Project: 30 – 40 Lawrence Road
Job No: 2024-5122
File Ref: N04-NB-Transport Note (250314)
Date: March 2025

Subject: **Transport Note – response to comments received by email on 25/02/25
and as discussed with Joshua O’Donnell on 13/03/25**

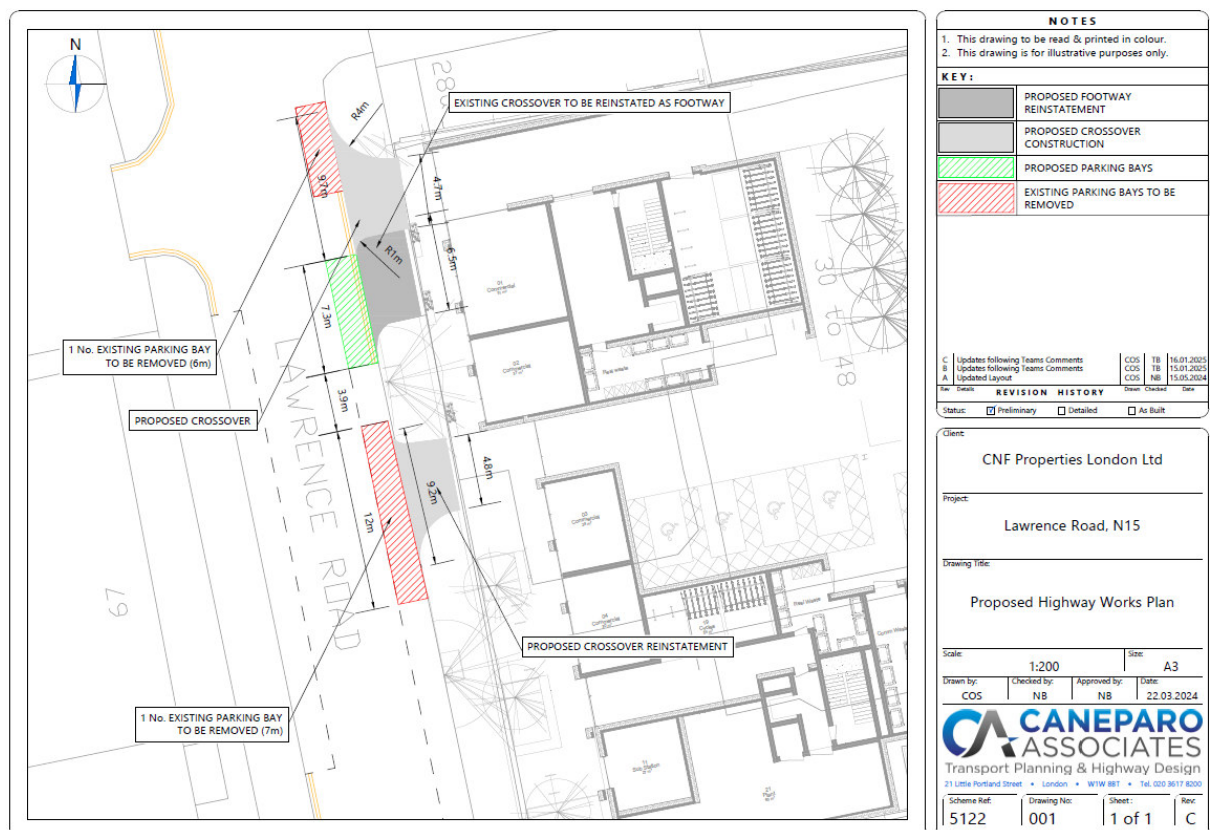
Gates – LBH comment – *“It appears though not clear that the development would be gated, are they able to confirm. If one is being provided, then the are they able to demonstrate that a vehicle could be fully berthed on the crossover without blocking the footway.”*

1. The northern access will contain a pedestrian gate, the main gate would only be opened for fire brigade access.
2. The southern access will be gated but this also generally be left closed, aside from fob/intercom access, and for use by pedestrians/cyclists and for access to the disabled parking bays.
3. To set the gate further into the site may provide an area for antisocial behaviour to potentially take place, which would be contrary to Secured by Design principles, but the exact details of the placement and specification of the gates can be conditioned.
